## SANITARY SEWER EXTENSION FOR

"HINDU TEMPLE ADDITION"

COW PRIV. PROJ. NO. 1129 PPS(607861)

APPROVED AS NOTED  
By CITY ENGINEER OF WICHITA

| SITE PLAN                                 |                        |         |

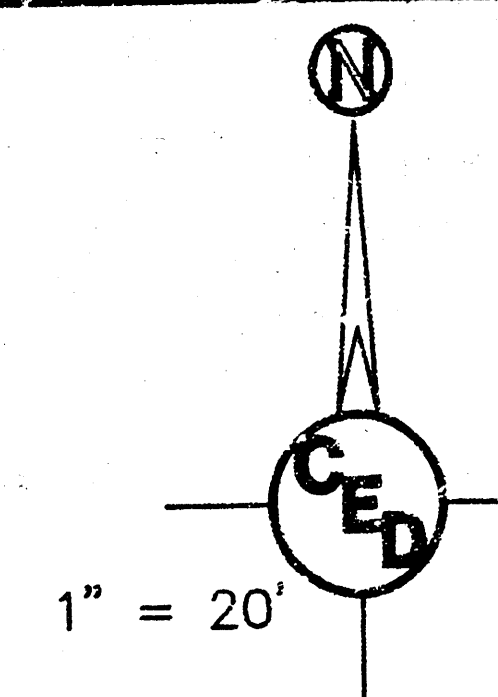
STA. 0+00, Begin Construction  
 N 4845.68  
 E 4822.65  
 Begin Construction  
 Exist. MH, Top Elev. = 186.26  
 Core Existing MH Wall. Install  
 New 8" Pipe. Seal New 8" Pipe  
 & Plug to MH Wall w/  
 Quick-Set Hydraulic Cement.  
 Concrete Encase 8" Pipe 3"  
 (Min.) from MH Wall. Fill all MH  
 Wall Imperfections w/  
 Quick-Set Hydraulic Cement.  
 FL IN (E) = ~~170.62~~ 171.14  
 FL OUT (W) = 170.62

STA. 0+29.66, Prop. SSMH 1  
 N 4846.37  
 E 4852.31  
 Install Type P Std. 4" Dia. MH  
 Top Elev. = ~~186.26~~ 185.05  
 FL IN (E) = ~~170.62~~ 171.43  
 FL OUT (W) = ~~170.62~~ 171.44  
 Install 10 L.F. of 4" Stub (E)  
 Stub FL = 177.35
